City of Aurora Building Division
Project: **Monarchs Events**
Address: **16786 E Iliff Ave**
Occupancy Group: **A3**
Construction Type: **UBC VN**
RSN: **1899006**
Permit: **2025-2530957-LT**

City of Aurora Building Division
Reviewed for Code Compliance
Approved as Noted: **Kirk Nagle**
Date: **Jun 17, 2025**
2021 INTERNATIONAL CODES & 2023 NEC

PROJECT SCOPE OF WORK

THIS PROJECT AND THESE PLANS ARE INTENDED TO DESCRIBE A MODIFICATION TO EXISTING A-3 OCCUPANCY, TENANT IMPROVEMENT/ALTERATION TO A PORTION OF AN EXISTING COMMERCIAL MIXED USE BUILDING IN AURORA, COLORADO.

Title:
PLUMBING FLOOR PLAN

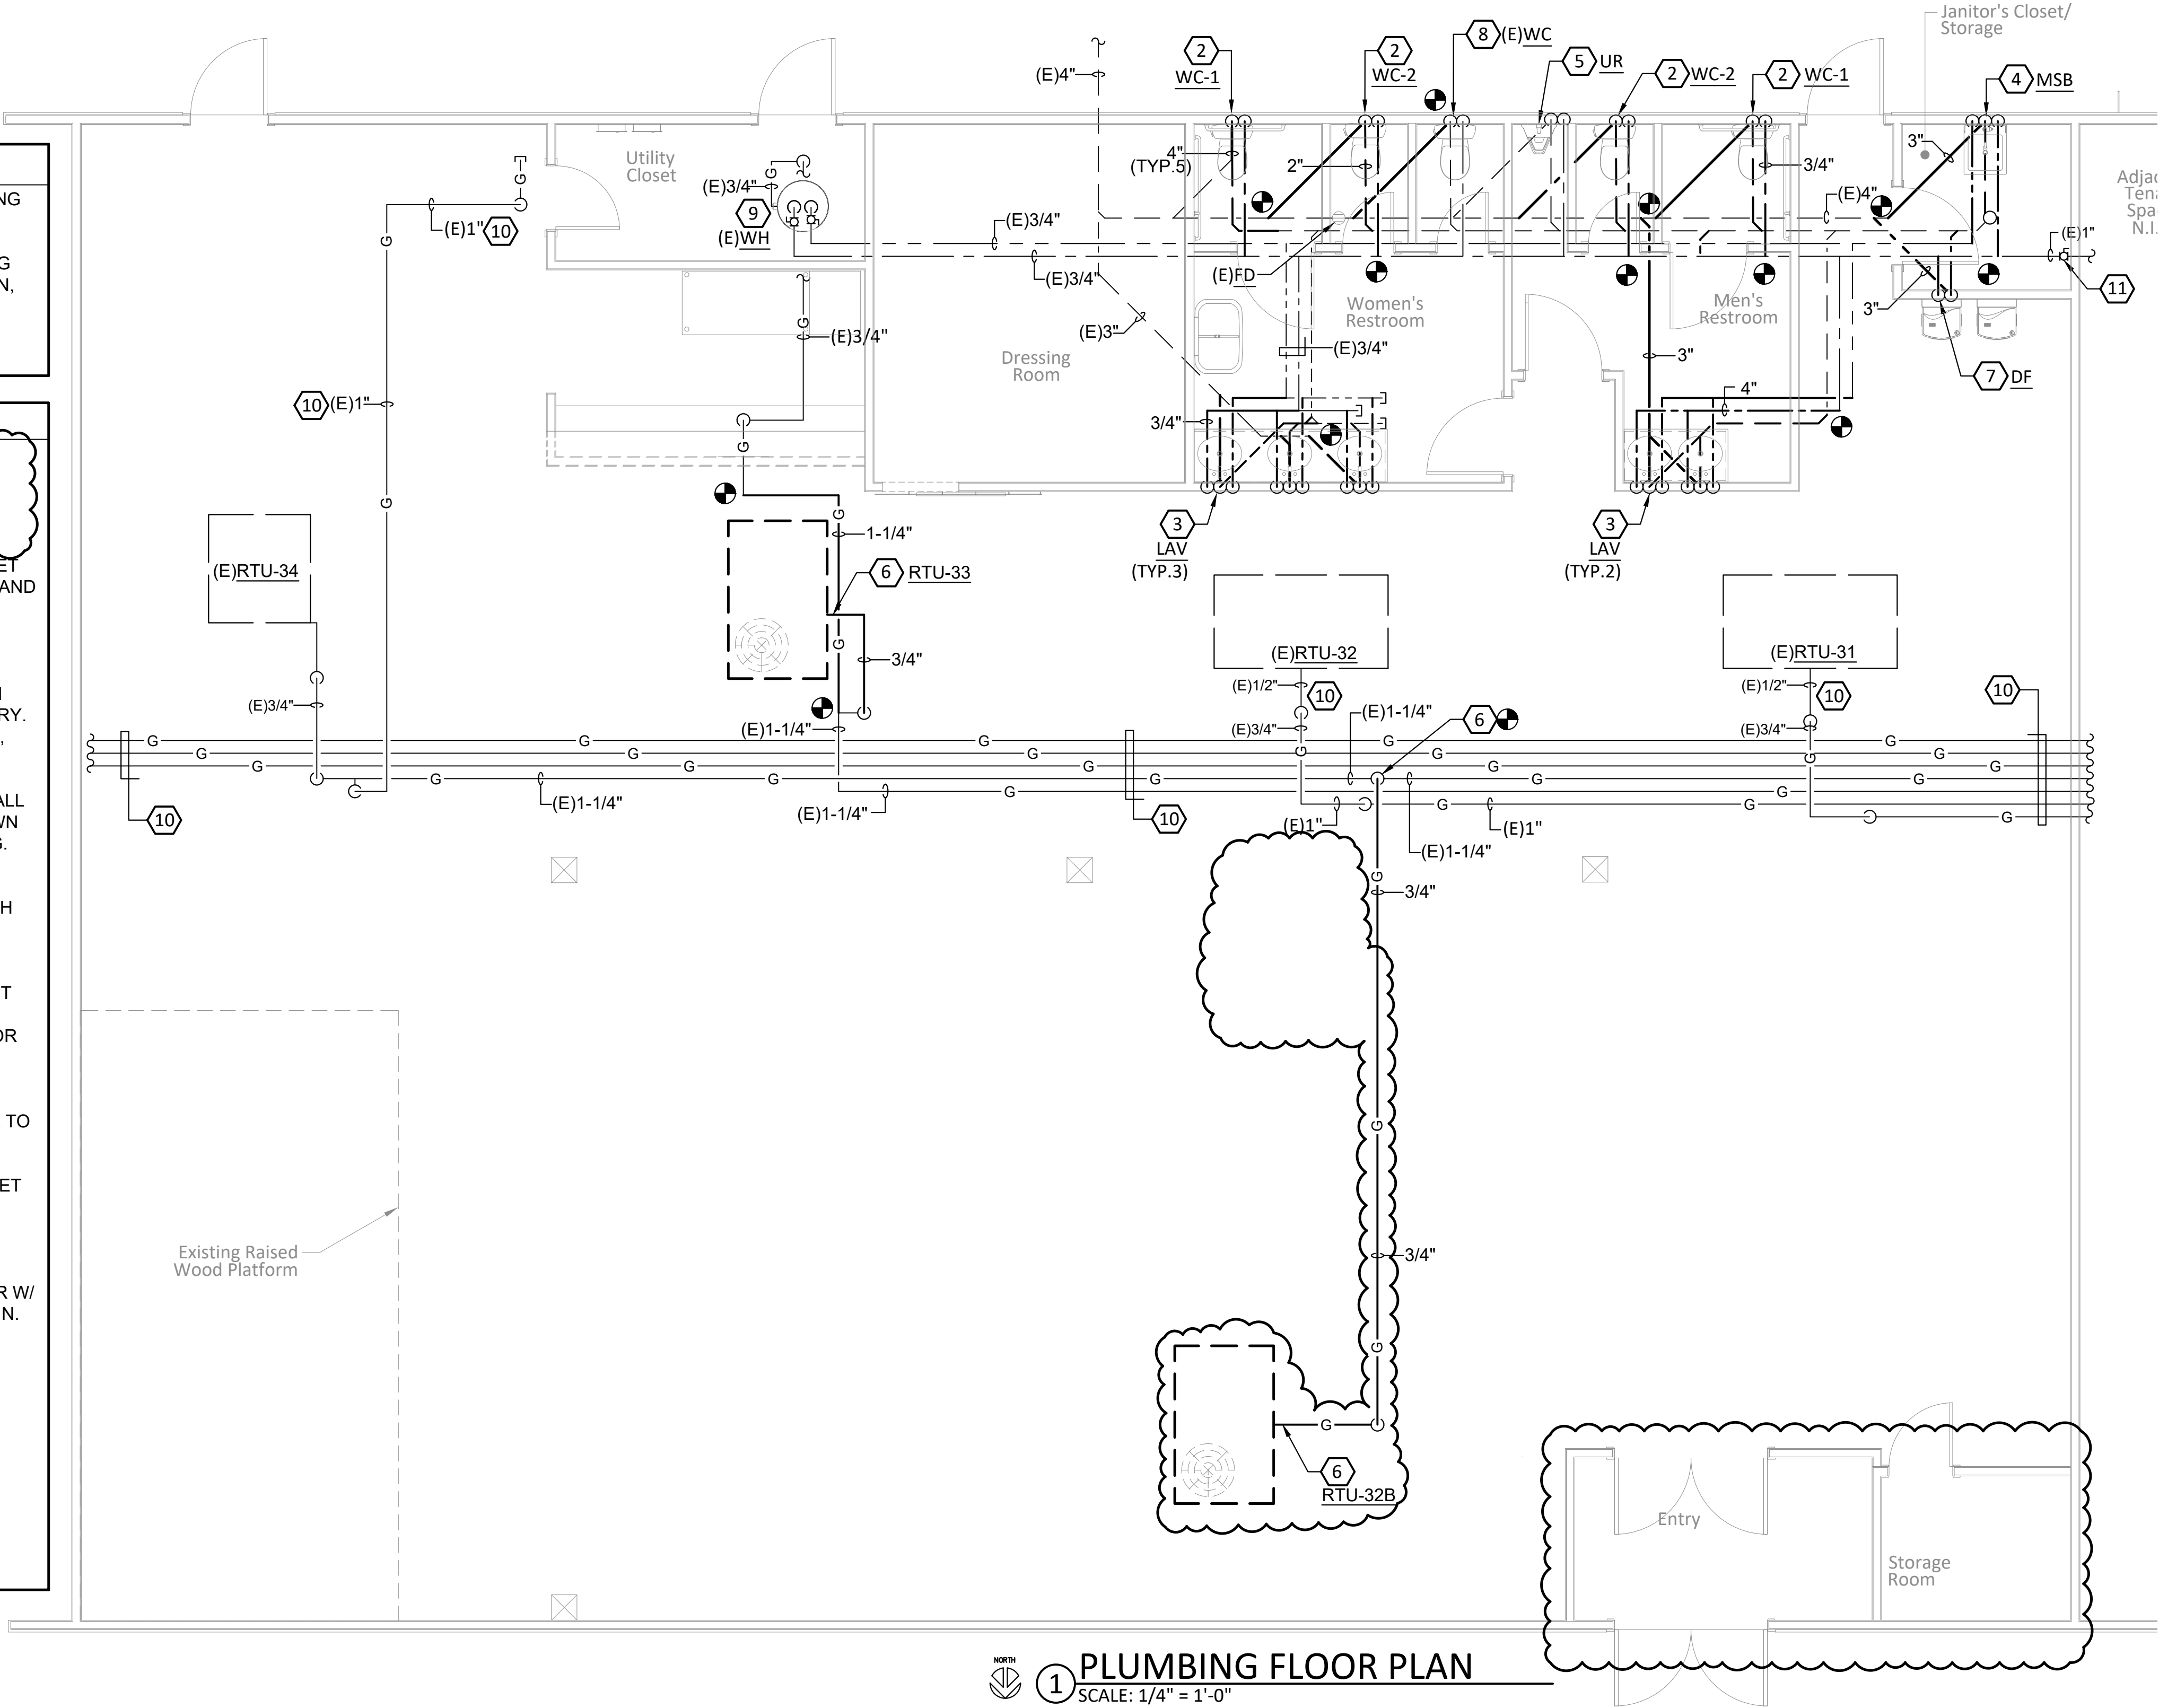
The dry vent must rise 6" vertically above the flood level rim of the highest trapped fixture being vented. **2021 IPC 905.4**

Provide drains no smaller than allowed by **2021 IPC 709.1 and 710.1(1)**

Provide self-closing or metered faucets in public restrooms. **2021 COA 22-326 (a)**

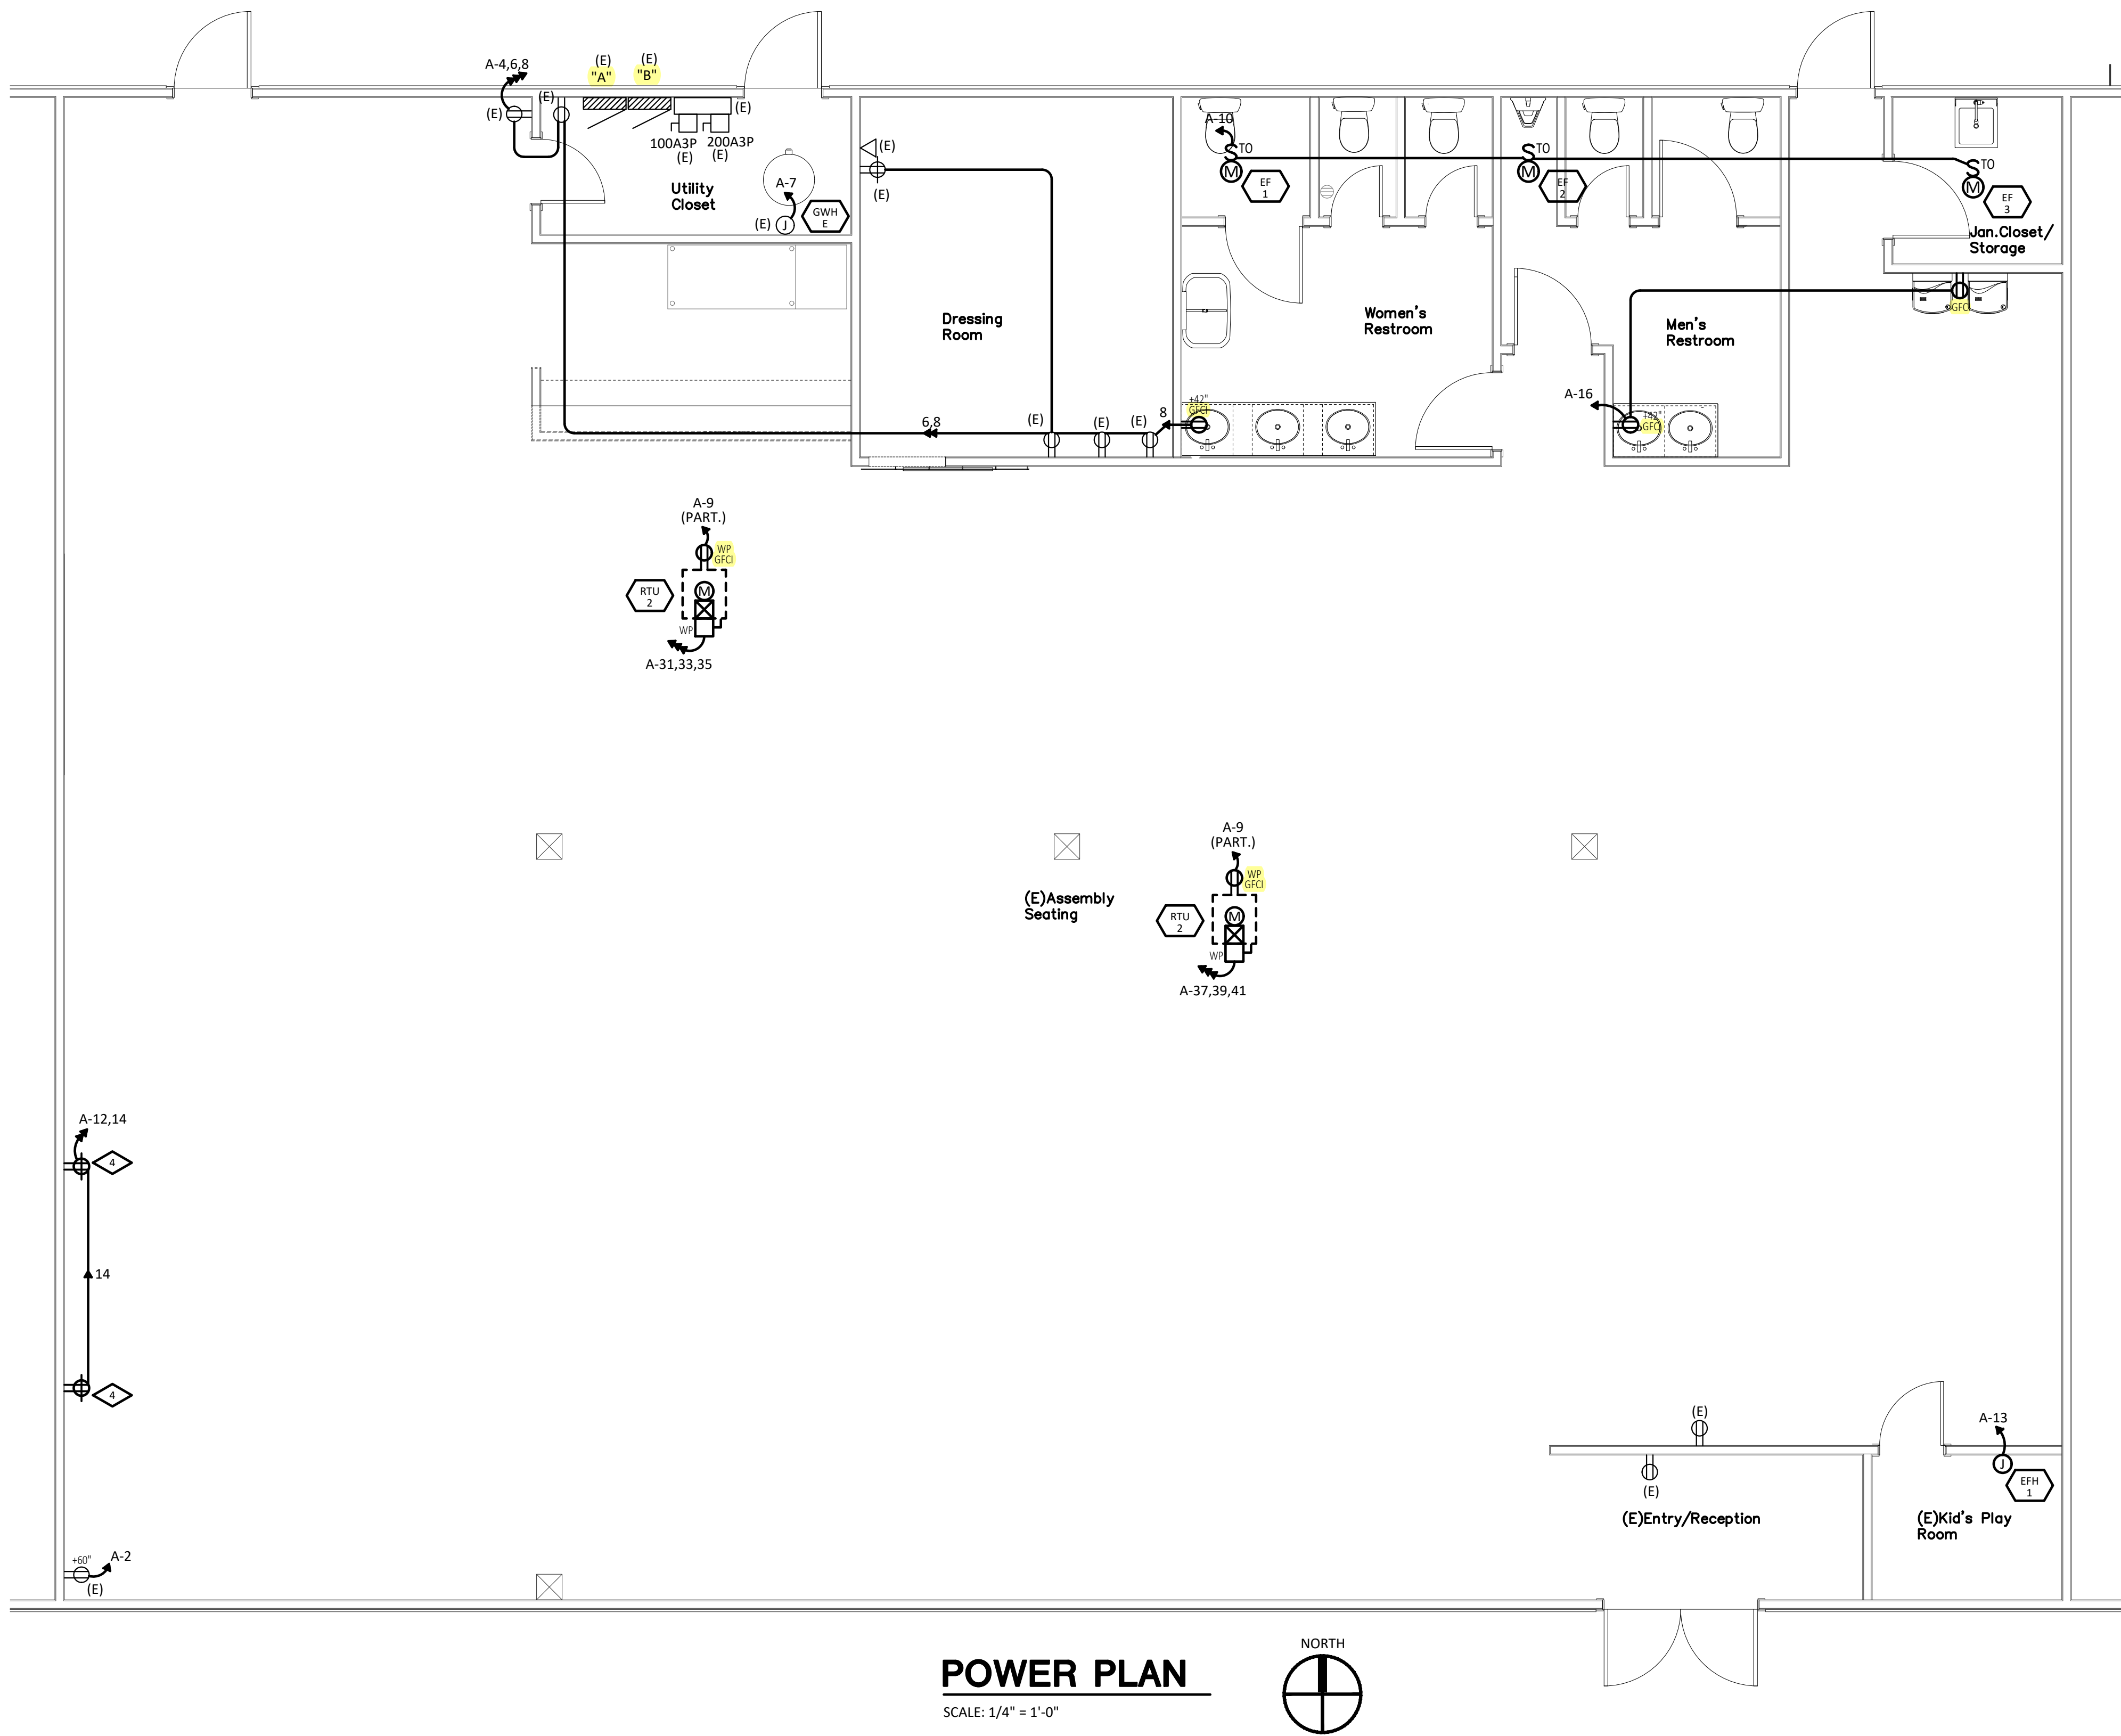
110.14. Identify disconnects per 2023 NEC 110.22 and provide working space and access to and around electrical equipment per 2023 NEC 110.26
